Access Compliance Report Public Rights-of-Way (Curb Ramps)

Intersection ID: 19457	Main Street: S_TRYON_ST	Cross Street: YORKDALE_DR	Location: NW
ADA ID: 3D205B7AE61E	Ramp Type: PerpDiag	Initial Pass/Fail: Pass	Overall Compliance: No Severity Score: 22.5

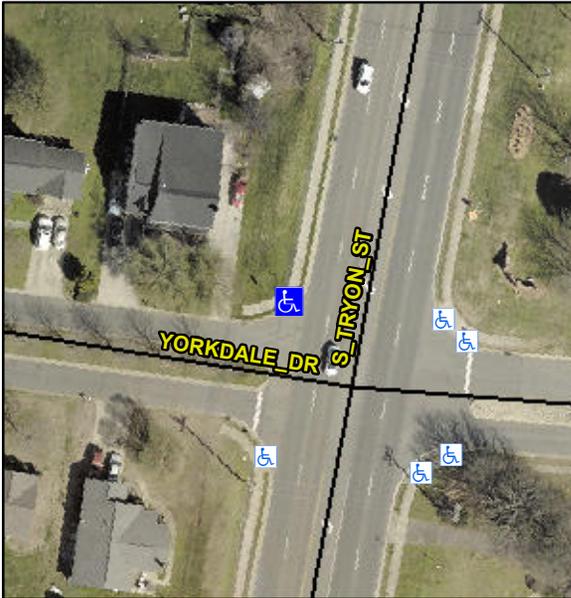
Compliance	Description	Data	Compliance	Description	Data
N/A	Ramp Length (in)	91.0	Yes	Ramp Slope (%)	7.7
Yes	Ramp Width (in)	48.0	Yes	Ramp XSlope (%)	0.6
N/A	Flare Type LT	Sloped	N/A	Flare Type RT	N/A
N/A	Flare Slope LT (%)	6.6	No	Flare Slope RT (%)	11.2
N/A	Flare Traversable LT?	Yes	N/A	Flare Traversable RT?	Yes
No	Landing Length (in)	N/A	No	DWS Provided?	No
No	Landing Width (in)	N/A	N/A	DWS Contrast?	No
No	Landing Slope (%)	N/A	N/A	DWS Length (in)	N/A
No	Landing X Slope (%)	N/A	N/A	DWS Full Width?	No
N/A	Landing Curb? (Y/N)	No	N/A	DWS Offset (in)	N/A
N/A	Shared Landing?	No			
Yes	Gutter Ponding?	No	Yes	Gutter Slope (%)	4.4
Yes	Gutter Lip Ht (in)	0.0	Yes	Gutter X Slope (%)	1.4
N/A	Painted X Walk1?	No	N/A	Painted X Walk2?	No
	X Walk 1 Direction	To S		X Walk 2 Direction	To E
N/A	X Walk 1 Width (in)	N/A	N/A	X Walk 2 Width (in)	N/A
	X Walk 1 Slope (%)	1.1		X Walk 2 Slope (%)	0.6
	X Walk 1 X Slope (%)	2.2		X Walk 2 X Slope (%)	0.0

N/A	Ramp inside XWalk1?	N/A	N/A	Ramp inside XWalk2?	N/A
	Road Slope (%)	1.6	N/A	Clear Space?	Yes
	Road X Slope (%)	3.8	N/A	Clear Space to XWalk (in)	N/A
Yes	Any Obstructions?	No	Yes	Storm Grate/Utility Hazard?	No
	Obstruction Type			Storm Grate/Utility Type	
			N/A		N/A
			Yes	Surface Condition? (G/P)	Good

Remove & Replace Curb Ramp With Two New Directional Ramps or Equivalent.
